MONITORING YEAR 2 ANNUAL REPORT

BANNER FARM MITIGATION SITE

RE: **Banner Farm Draft MY2 Report Review
French Broad River Basin – CU# 06010105
Henderson County
DMS Project ID No. 100062
Contract # 7530**

Wildlands Engineering, Inc. (WEI) has reviewed the Division of Mitigation Services (DMS) comments from the Draft MY2 Monitoring report for the Banner Farm Mitigation Site provided in bold type below and offers the following responses in italics.

Figure 1a-e Current Condition Plan View Maps

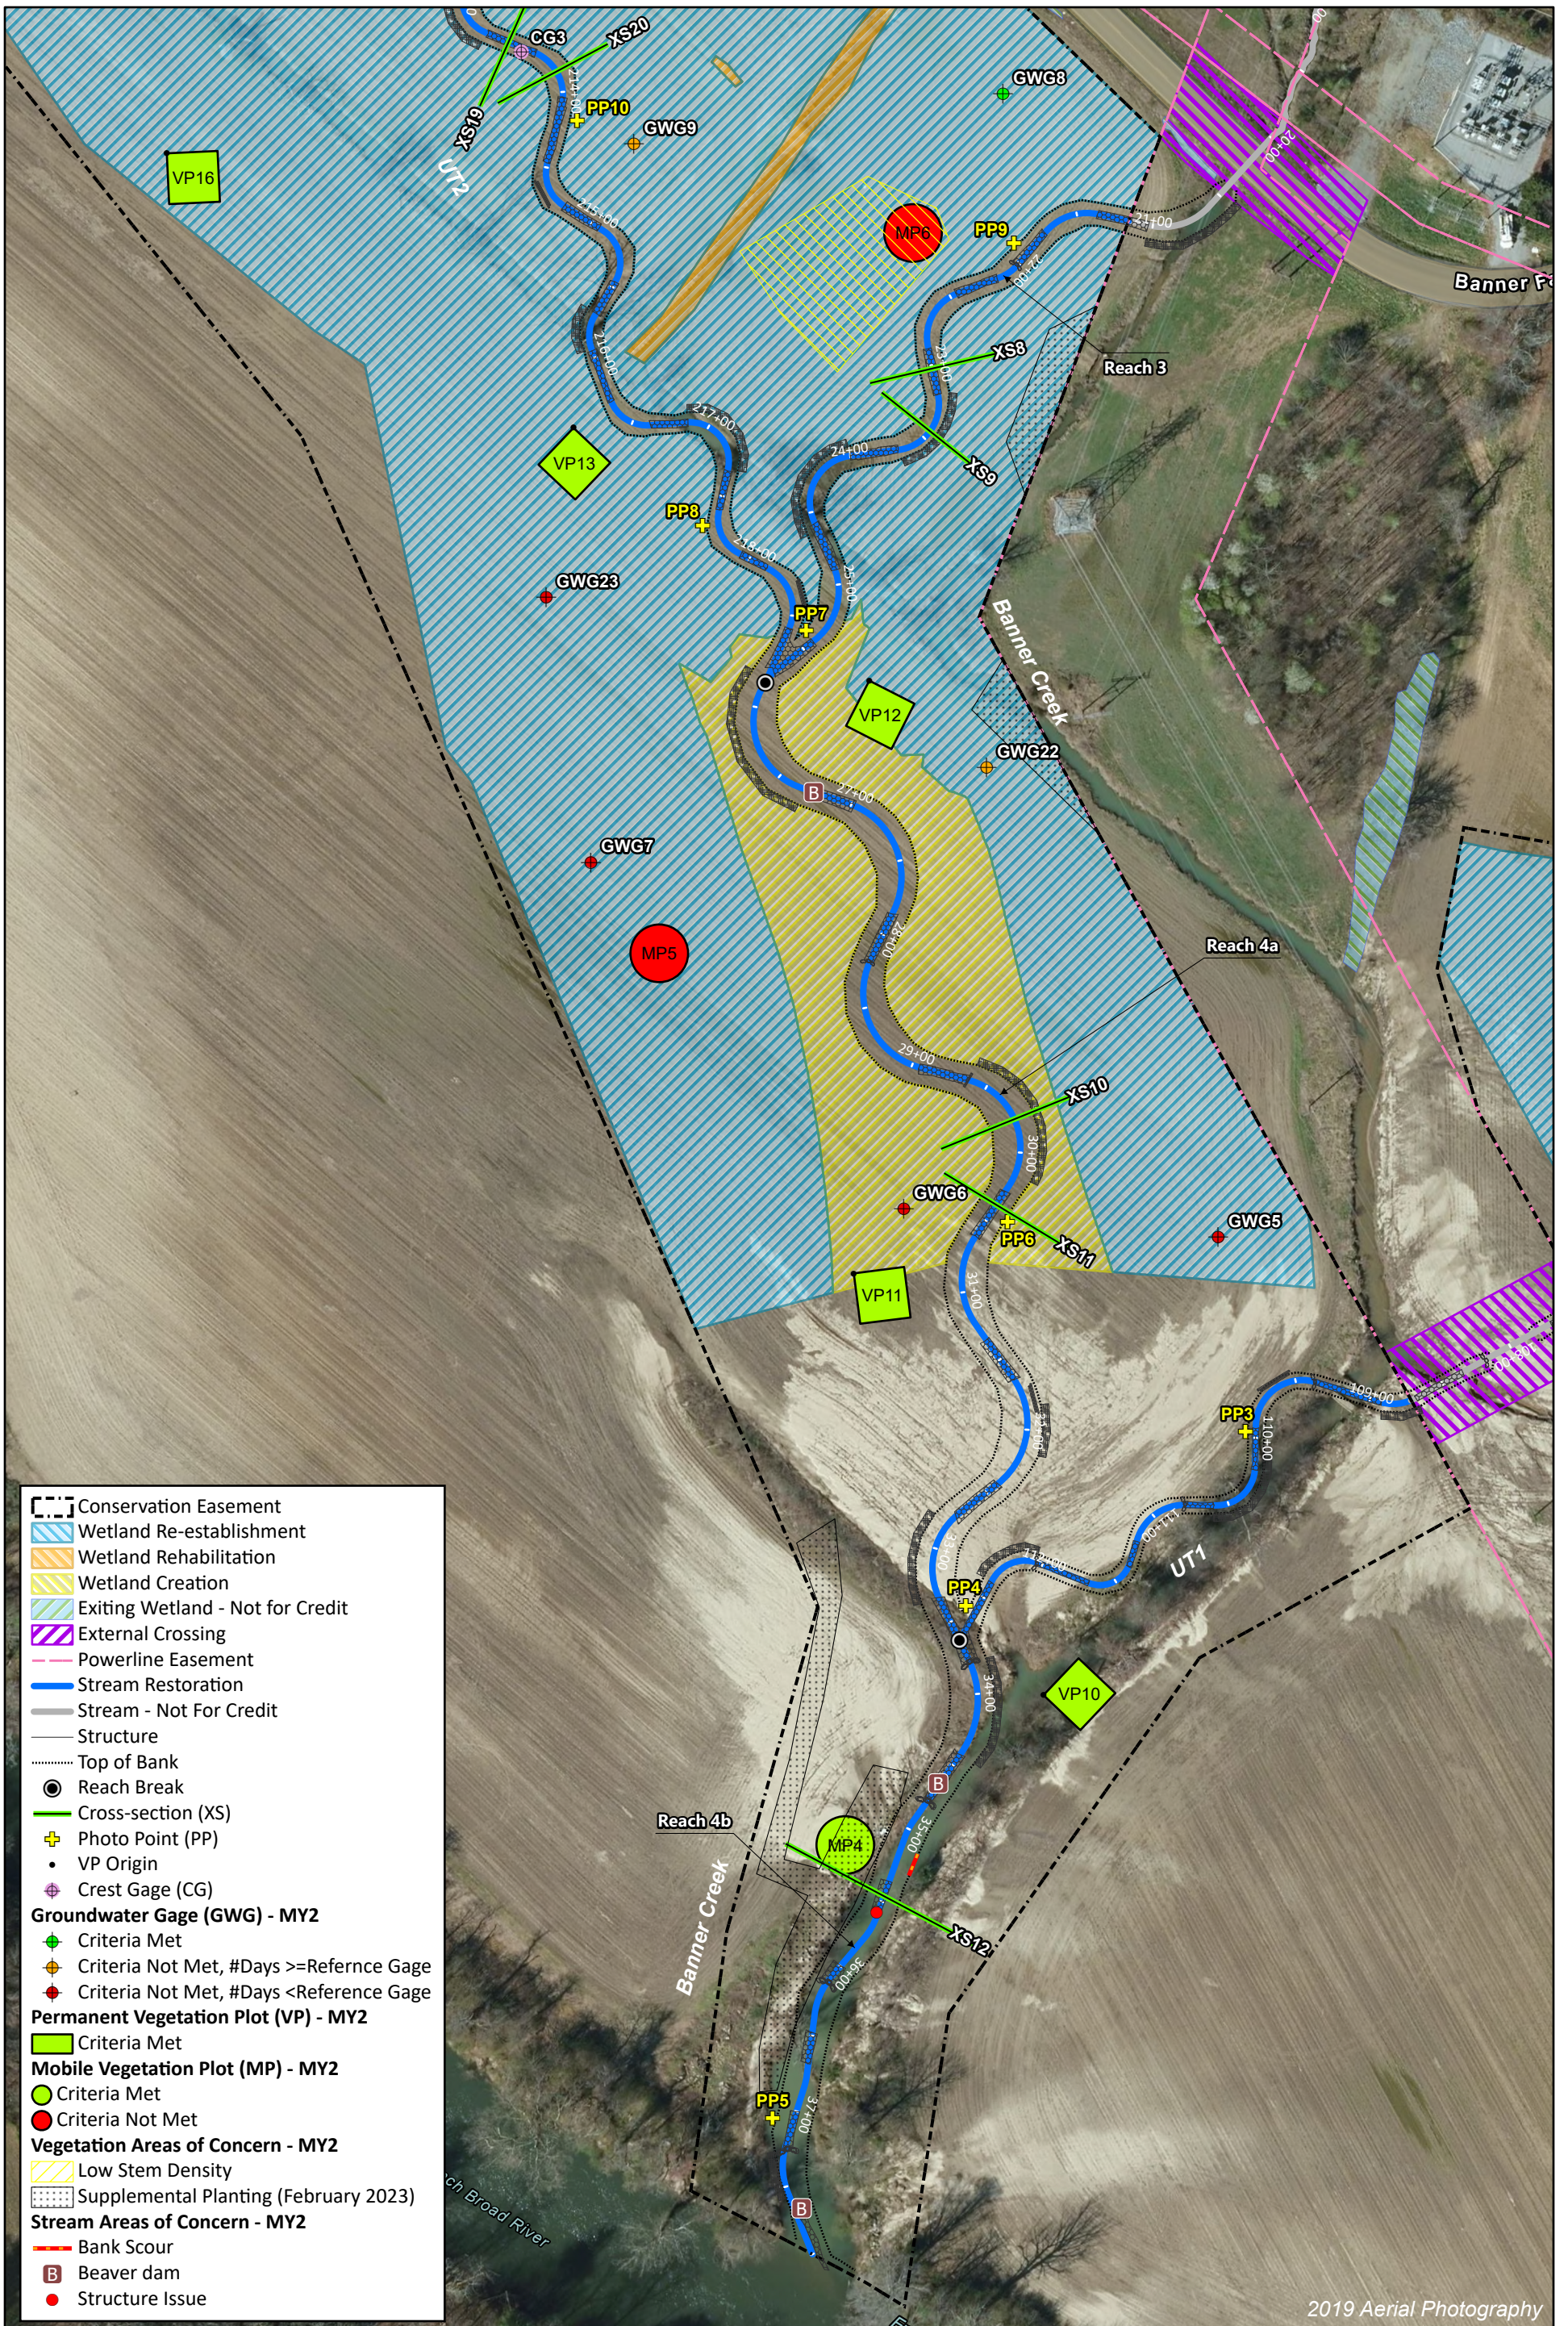
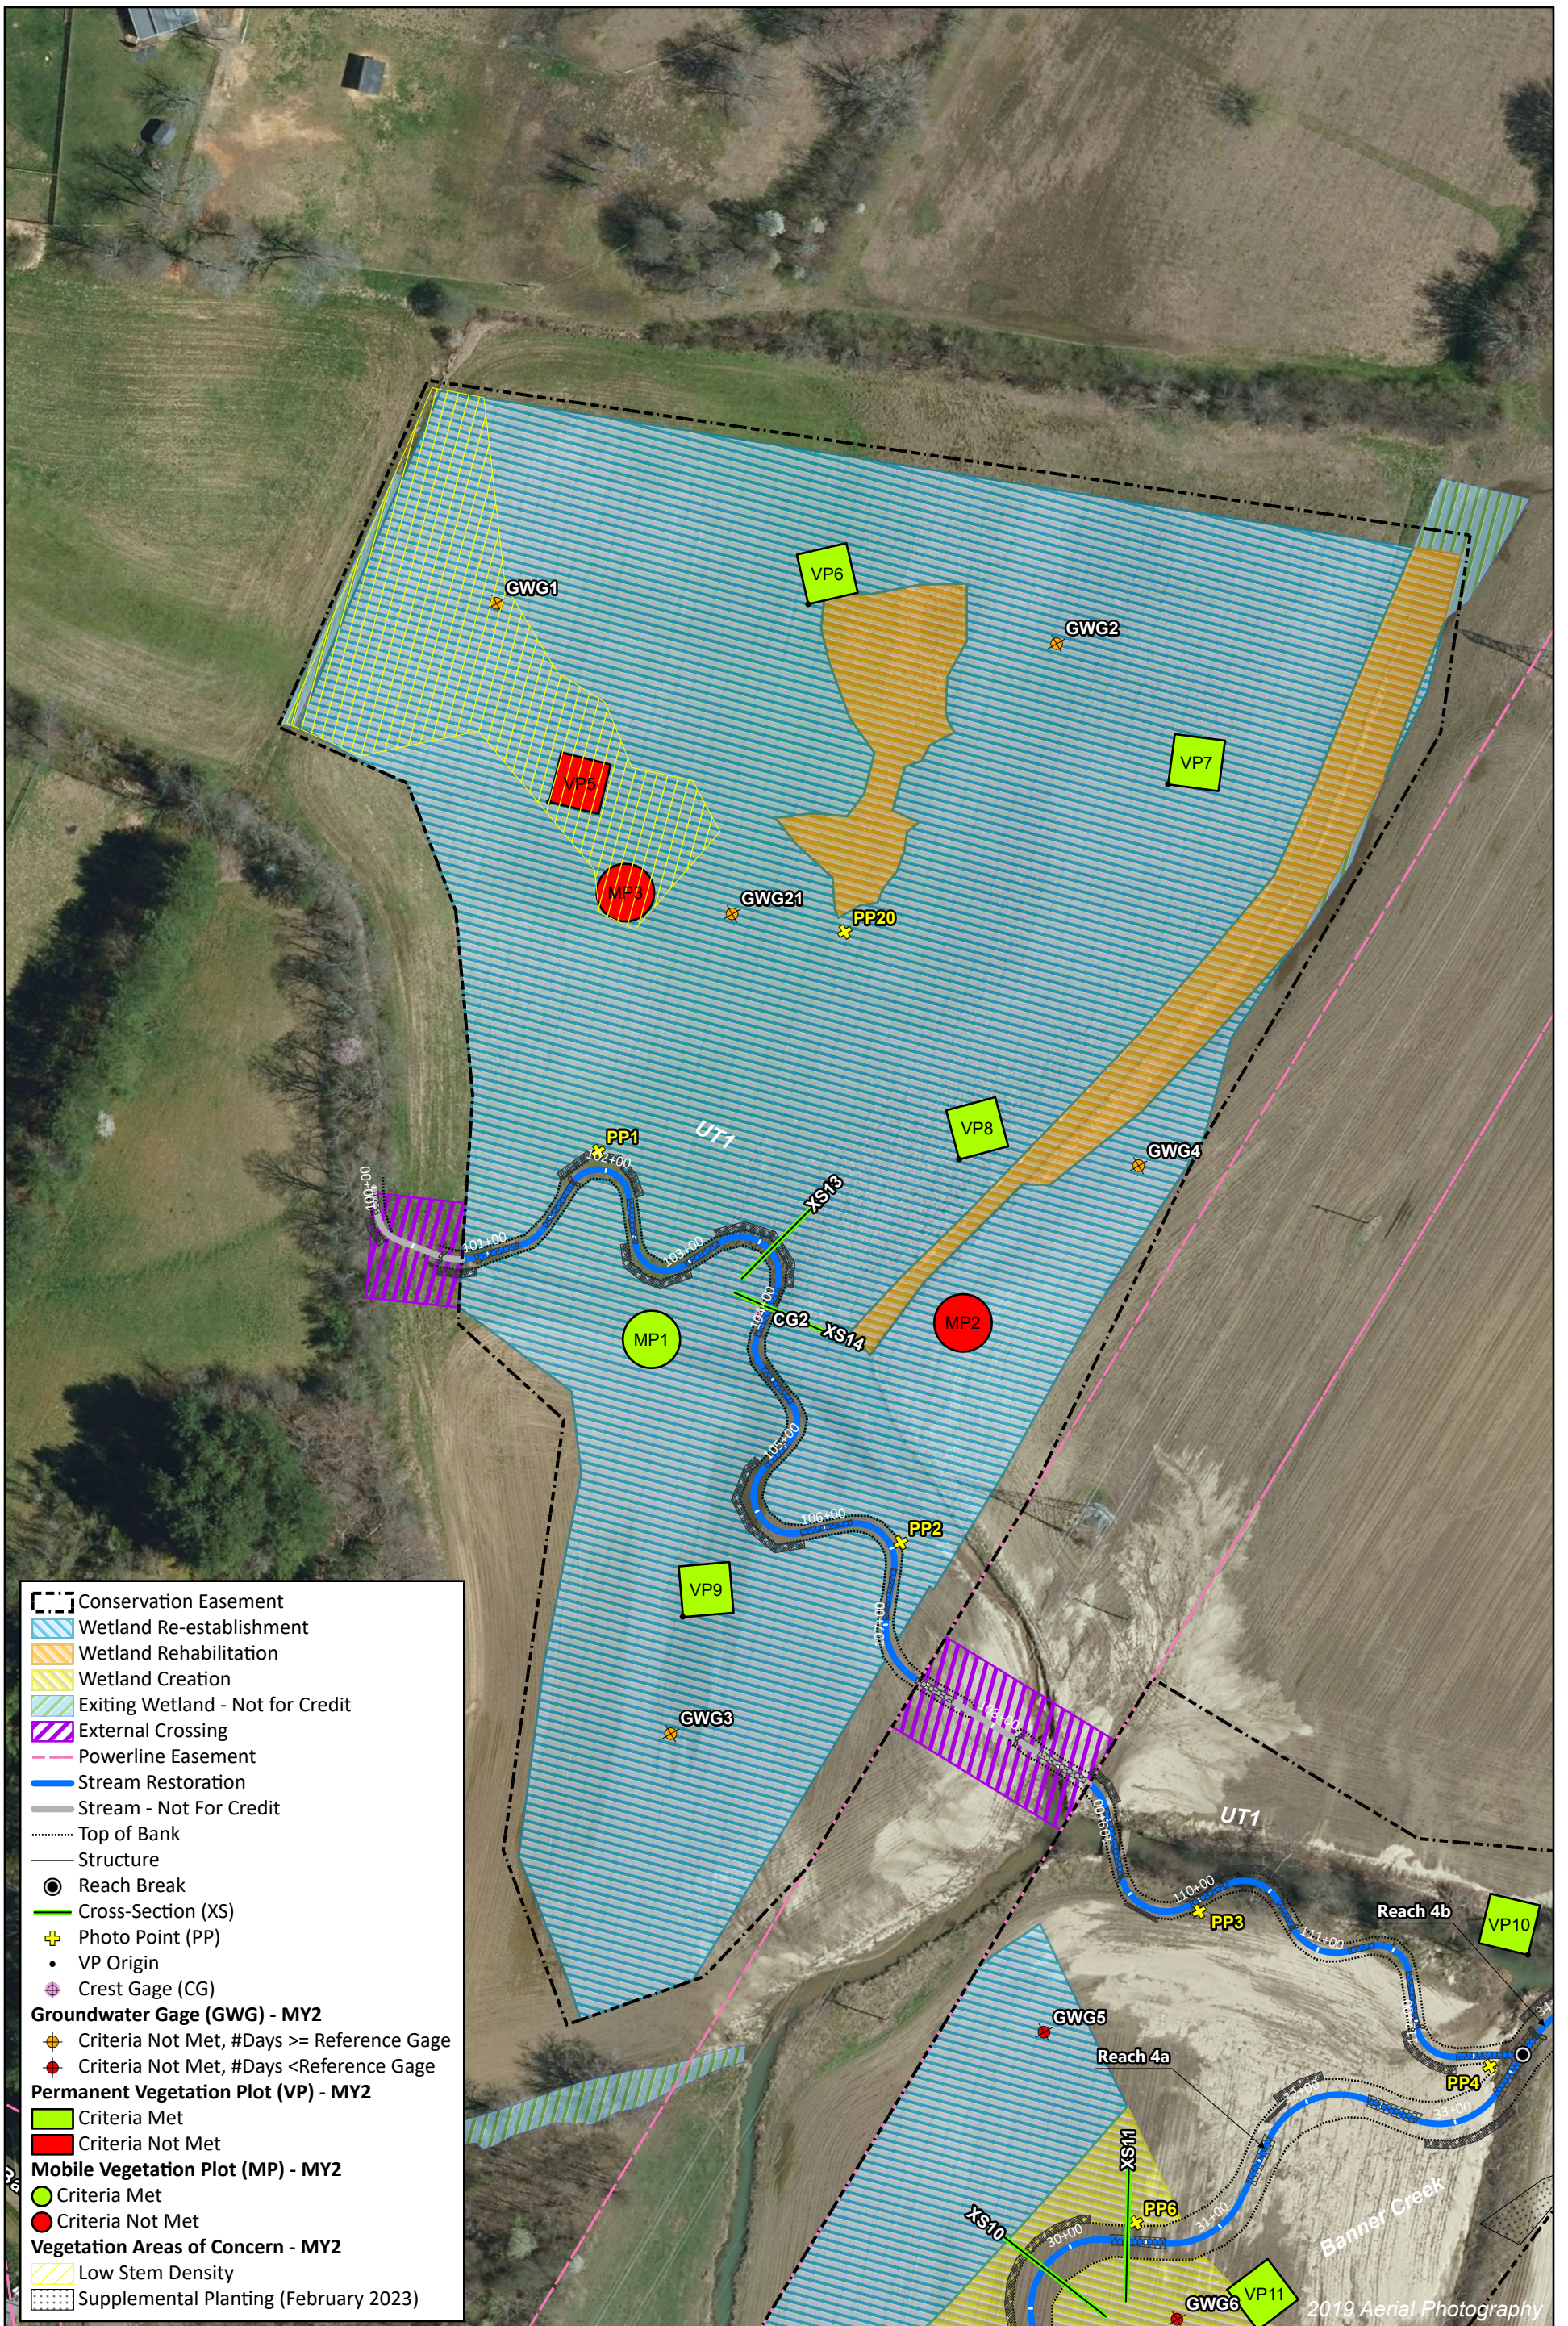
The floodplain pool located in the southernmost portion of the site was planted with live stakes and whips in February 2023. Has this effort been successful? Has the floodplain pool reduced in size? Please show the perimeter of the floodplain pool on the CCPV.

Resolved Easement Encroachments: Thank you for including the Resolved Easement Encroachment List table. This information is greatly appreciated. Please add the location of the resolved easement encroachments to the CCPV.

Wildlands Response: In September 2022 (MY1), herbaceous plugs were planted in the floodplain pool and woody live stakes and whips were added in February 2023 (MY2). These efforts have been successful, and the floodplain pool has reduced in size, though the perimeter varies seasonally. Photos of the floodplain pool have been added to the Supplemental Photographs Log in Appendix A. The current perimeter of the floodplain pool has been added to the CCPV figures.

Wildlands Response: The locations of the resolved easement encroachments have been added to the CCPV figures.
